SAFETY RECALL BULLETIN

February, 2018
18R4 (FL754)
NHTSA #17V-730
Transport Canada #17-569

Subject: **Detroit™ DT12™ Transmission Range Spring Detent Screw**

Figure 2 – Range Shift Fork Detent Spring Nut Cap

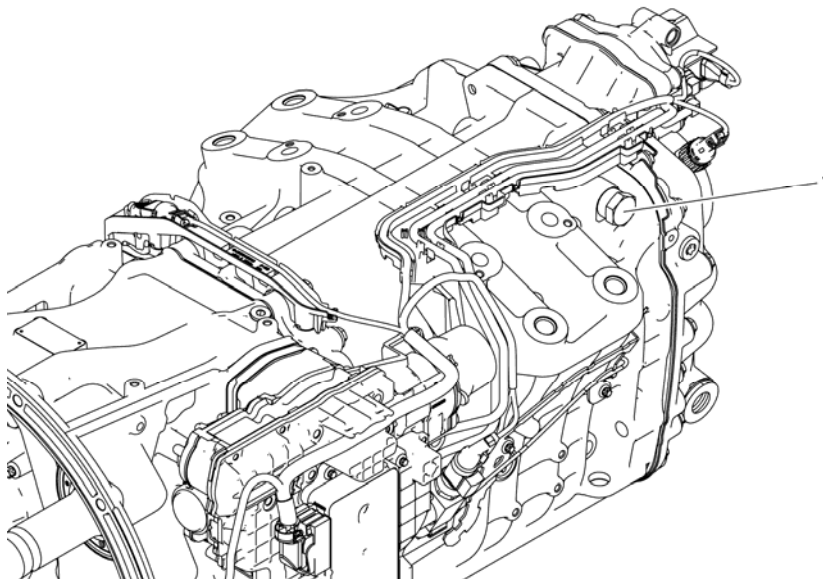
The range detent spring is under pressure, and must be held back to prevent the spring from catapulting the shift fork detent spring nut cap, possibly causing thread damage to the case and potential injury from flying parts.

5. Remove the range shift fork detent spring nut cap (1). As the nut is removed, push in with enough force to prevent the spring from catapulting the nut cap. See Figure 2.
